VIRGINIA ELECTRIC AND POWER COMPANY (DOMINION)
NORTH ANNA POWER STATION UNITS 1 AND 2
PROPOSED TECHNICAL SPECIFICATIONS CHANGES AND EXEMPTION
REQUEST FOR USE OF FRAMATOME ANP ADVANCED MARK-BW FUEL
SUPPLEMENTAL INFORMATION FOR REALISTIC LARGE BREAK LOSS OF
COOLANT ACCIDENT (RLBLOCA) HEAT TRANSFER MODEL

**Supplemental Response to Request for Additional Information
Radiation Heat Transfer Model from
December 8, 2003 letter (Serial No. 03-313H)**

Dominion Supplemental Response to NRC Request for Additional Information
North Anna Realistic LBLOCA Analysis
Radiation Heat Transfer Model from
December 8, 2003 letter (Serial No. 03-313H)

Figure 1. 6x6 Assembly Array Modeled for rod-to-rod Radiant Heat Transfer Calculations.

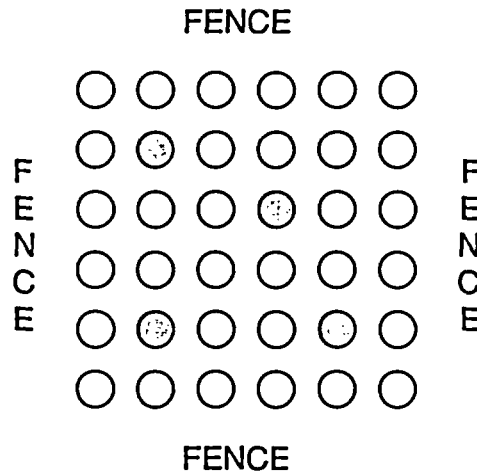
In a telephone conference call on December 15, 2003, the NRC Staff requested the details of the radiation enclosure used to demonstrate that the minimum thermal radiation expected in the North Anna core for the hot rod bounds the reflood test data used to develop the RELAP5 core heat transfer model. This includes showing the 5x5 array and fence, showing the location of hot rod, guide tube thimbles and fence. Also present the temperature assumed for the hot rod, surrounding rods, rod thimble and fence at the time of PCT used to compute the equivalent radiation heat transfer coefficient for the hot rod to the surrounding surfaces. If the pin radial peaking factors are provided for the enclosure, please provide PCT for the average assembly rod and hot rod.

The radiant heat transfer analysis performed using the R2RRAD code modeled the 6x6 assembly array presented in Figure 1. As stated in the previous responses (Dominion letters 03-313G and 03-313H), the R2RRAD code was modified to: a) examine 6x6 assembly arrays (rather than 5x5), b) account for the larger diameter guide tube rods (shaded rods in Figure 1), and c) calculate an average assembly radiant heat transfer coefficient. To address the potential variation of local power peaking associated with the sampling process inherent in the FANP RLBLOCA methodology, a bounding R2RRAD analysis was performed. The calculation assumes that the hot rod temperature is equal to the average hot assembly rod temperature. This approach is equivalent to assuming a flat distribution of local peaking factors within the assembly; it represents the condition providing an absolute minimum radiant heat transfer. Table 1 presents the temperature

parameter values applied in this bounding analysis. Rod and guide tube temperatures were obtained from the limiting PCT S-RELAP5 RLBLOCA calculation. The fence temperature is an average of the surrounding assembly temperatures and the hot assembly temperature. [Note: the fact that both the guide tube and fence temperatures are equivalent is coincidence].

Since this approach makes the hot rod indistinguishable from an average rod, there is no particular influence of the hot rod location. The resulting average and maximum radiant heat transfer from the R2RRAD analysis is given in Table 2. While the analysis results reflect a lower radiant heat transfer component relative to the analysis presented in the original RAI response, these results still bound the FLECHT-SEASET and FLECHT-Skewed results.
